## Global Change Notification (GCN)

GCN Number

Series

Before and after the rib change

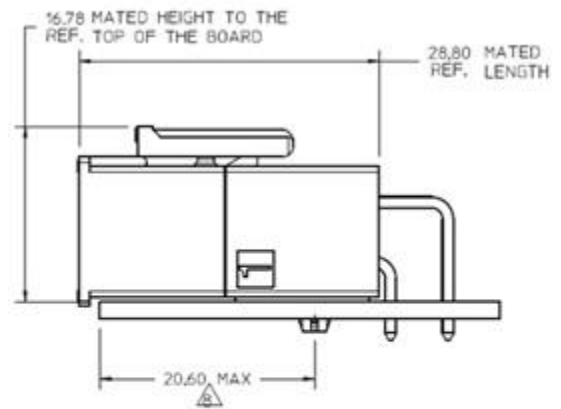
Change Description

⚠ TO AVOID INTERFERENCE BETWEEN RECEPTACLE AND PCB, HEADER MUST BE PLACED WITHIN 20,6 MAX FROM EDGE OF PCB AS SHOWN FOR 4 THRU 12 CKTS, FOR 2CKT PARTS THIS DIMENSION IS 15,1 MAX.
